Statement of Compliance Access For People With A Disability

Macquarie Village
110-113 Herring Rd Macquarie Park

Accessible Building Solutions
124 Upper Washington Drive
Bonnet Bay NSW 2226

Section 1: Concept Plan

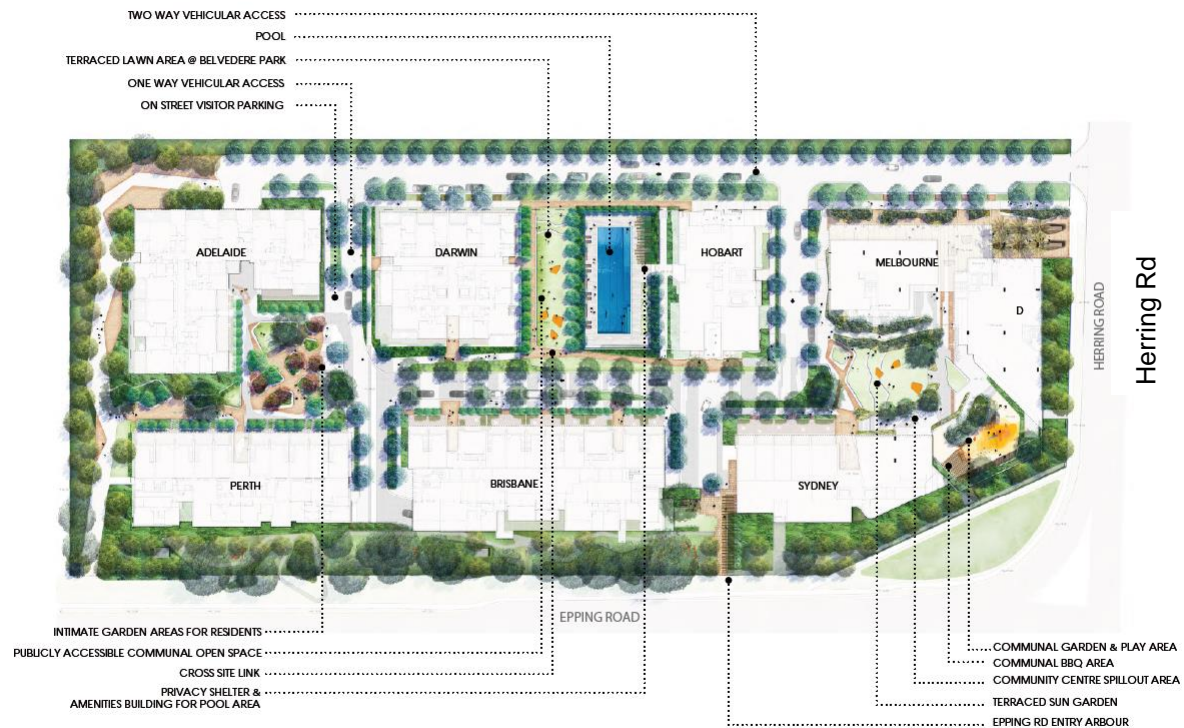
The proposal includes the construction of a road network linking 7 residential buildings.

- Footpaths providing an accessible path to each building from the street
- On street and basement carparking
- Kerb ramps to AS 1428.1 to provide access from the road to the footpath level
- Access to all levels of each building by way of a lift complying with BCA 2013.
- Access to communal facilities.

I am satisfied that the proposal will provide appropriate access for people with disabilities throughout the development.

Section 2: Stage 1 Proposal

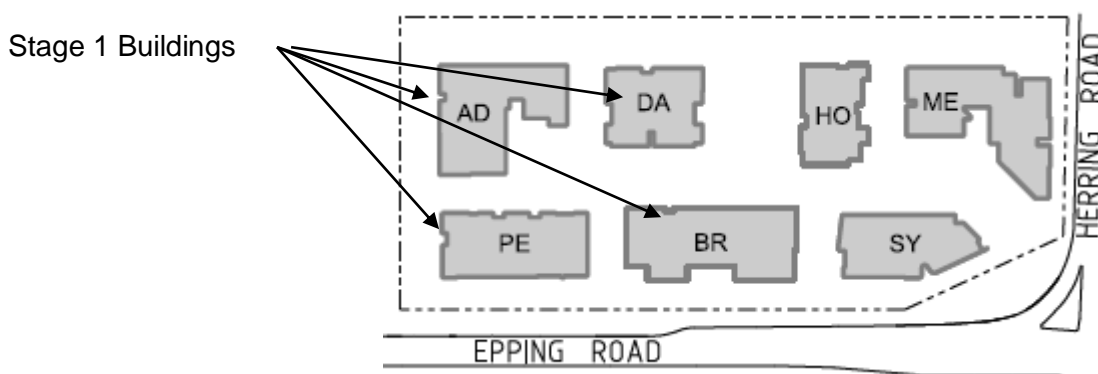
The Stage 1 proposal comprises 4 buildings as indicated below. These buildings vary in height, with apartments on all levels and basement carparking. They are accessed by a network of internal roads and pedestrian paths. The roads and paths provide access from the street frontage to all buildings and to common facilities. A communal swimming pool is centrally located.
